REMARKS

Annotated Marked-up
Drawing

FIG. 2

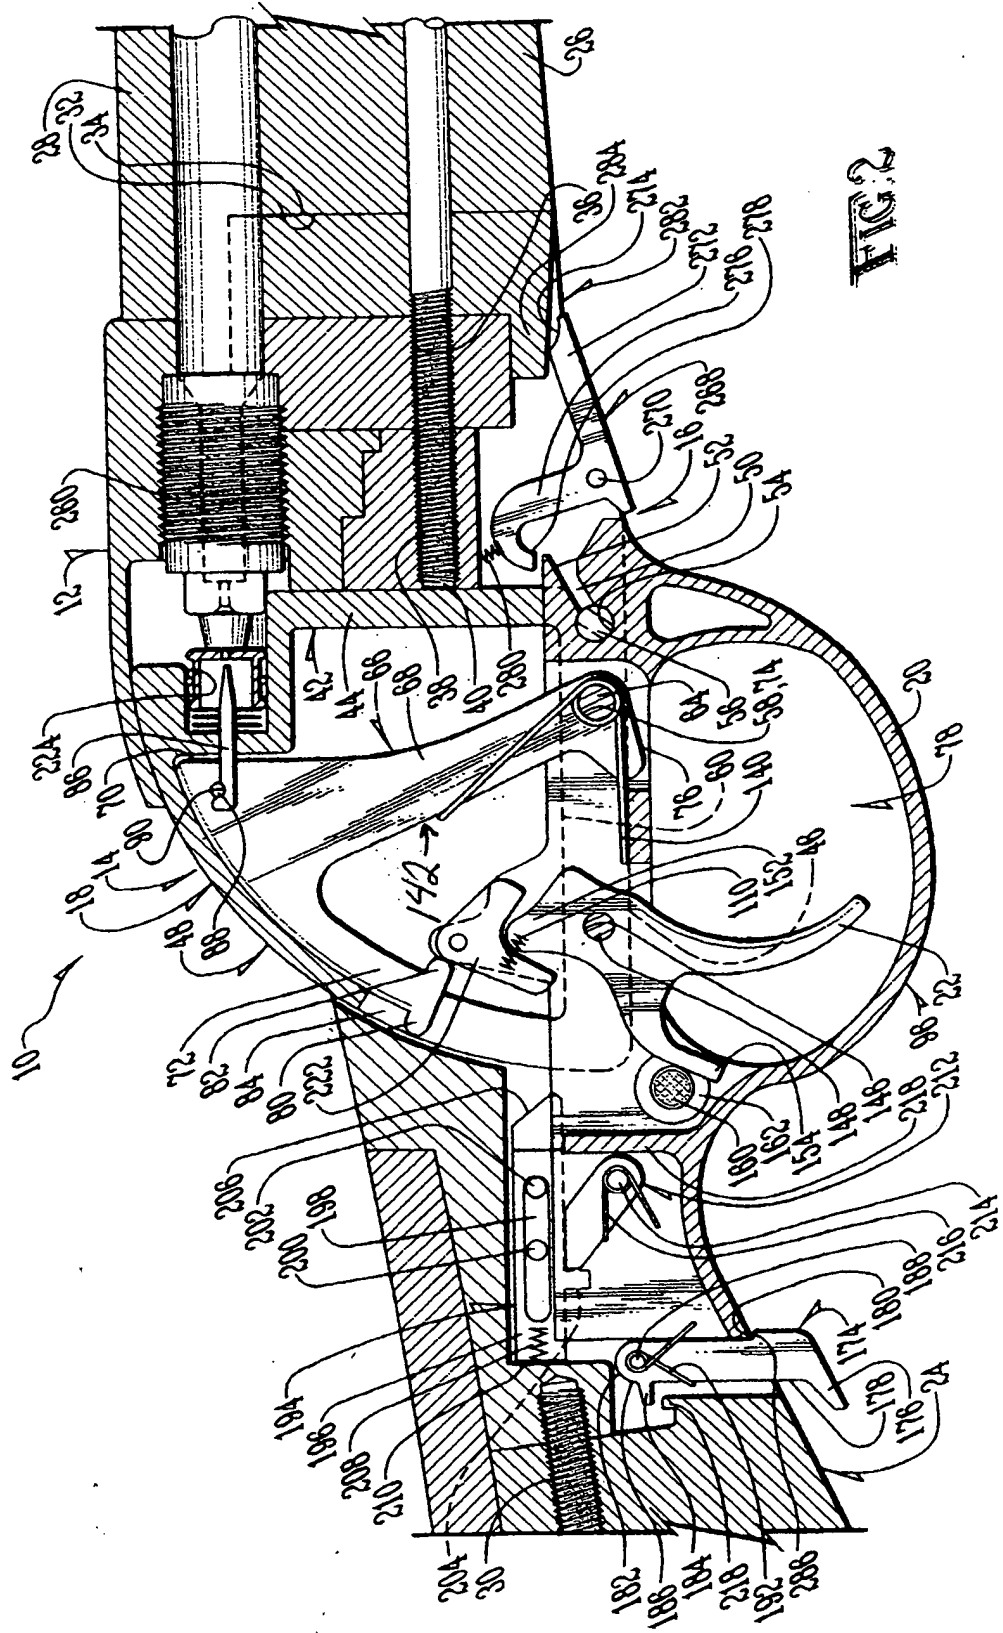
In the Office Action dated June 9, 2004, the Examiner objected to the drawings because numerical indicator (142) was not illustrated. Accordingly, Applicant respectfully submits a proposed drawing correction shown in red to Figure 2. Applicant respectfully requests the Examiner accept the proposed drawing change and withdraw the objection to the drawings.
